<b>Request</b>	<b>Modifications/Project Revisions</b>
<b>Project Name</b>	<b>12<sup>th</sup> at Broadway</b>
<b>Council District</b>	19 – O’Connell
<b>Requested by</b>	Endeavor Real Estate Group, HKS applicant
<b>Staff Recommendation</b>	<i>Approve with conditions</i>

## Downtown Code DRC Meeting of 03/02/2017

<b>Request</b>	<b>Modifications to DTC Standards</b>
<b>Project Name</b>	<b>USSTC Overflow Parking</b>
<b>Council District</b>	19 – O’Connell
<b>Requested by</b>	Jonathan Paulk, Siteworks LLC, applicant; Brad Montgomery, US Smokeless Tobacco Co., owner
<b>Staff Recommendation</b>	<i>Approve.</i>

<b>Request</b>	<b>Modifications to DTC Standards</b>
<b>Project Name</b>	<b>Capitol View Block E</b>
<b>Council District</b>	19 – O’Connell
<b>Requested by</b>	Kyle Reis, Cooper Carry, applicant; North Charlotte Avenue Holdings LLC, owner
<b>Staff Recommendation</b>	<i>Approve with conditions.</i>

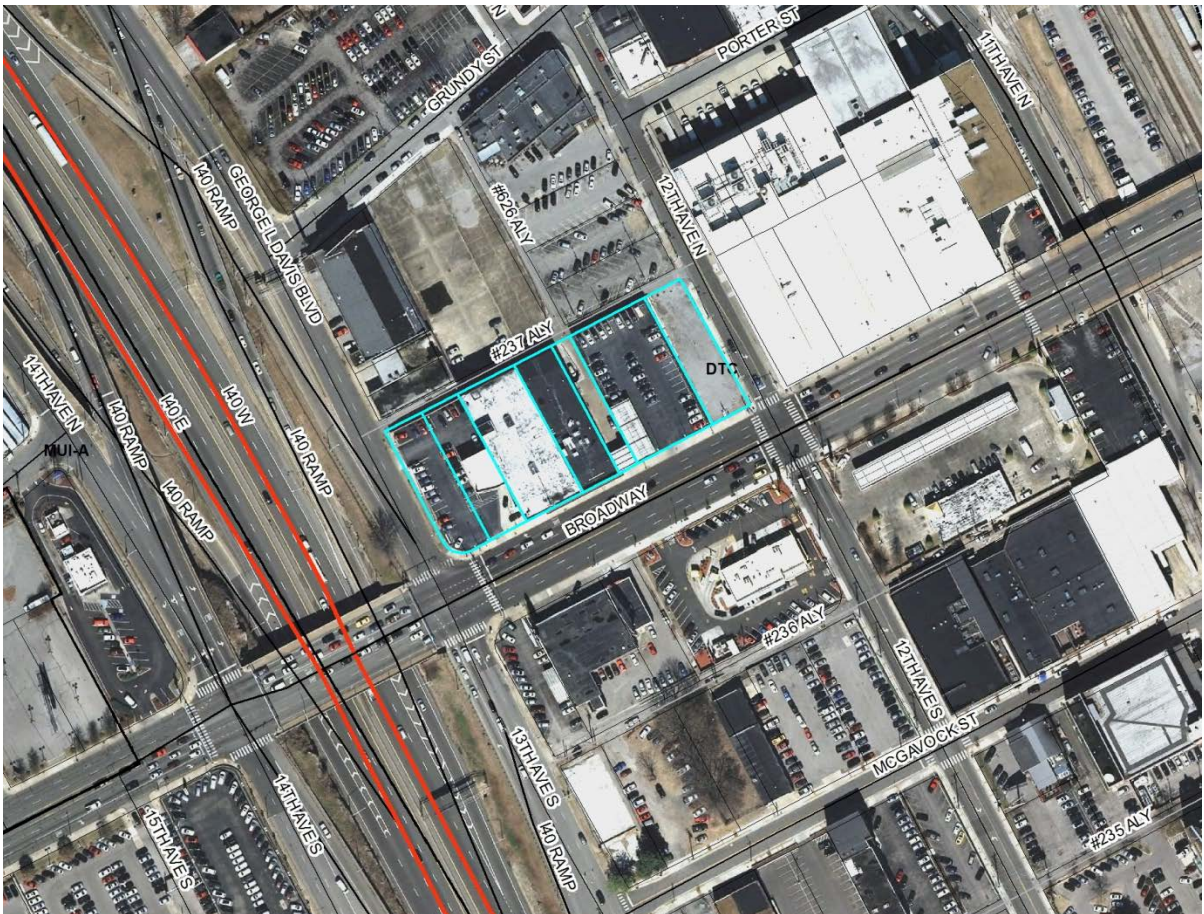
There are details that staff recommends additional consideration. The corner of 12<sup>th</sup> and Broadway is a prominent intersection in downtown, and care should be taken to ensure the building adequately addresses the corner in a successful manner. The proposed revision does begin to address the corner by having the glass come down the corner façade. The increased glazing serves to break-up the monolithic garage plane along Broadway as well. However, the original approved plans included a canopy at the corner to create a pedestrian scale to the building. The canopy has since been omitted from the design, with the ground floor retail storefront design to be determined by the tenant(s) at a later time. Staff recommends pedestrian scaled elements, such as the canopy, be reincorporated in the corner ground floor design.

Along the George L. Davis frontage, the applicant is proposing a mural/art wall to provide visual interest to the blank areas of the facade. Along the alley elevation, the upper floor garage treatment should also turn the corner to match the proposed art mural on the lower facade.

1. The 12<sup>th</sup> and Broadway corner of the building shall re-incorporate pedestrian scaled elements, such as a canopy. Staff to review and approve.
2. George L. Davis facade to include the mural/art wall as proposed. Other alternatives such as glazing may be considered and approved by staff.
3. Along the alley frontage the upper floor garage screening shall turn the corner for the same distance as the proposed mural, not less than 20' in length.
4. The retail tenant storefront will be required to meet the DTC standards at the time of its development.
5. Project must meet all Major and Collector Street Plan streetscape improvements.
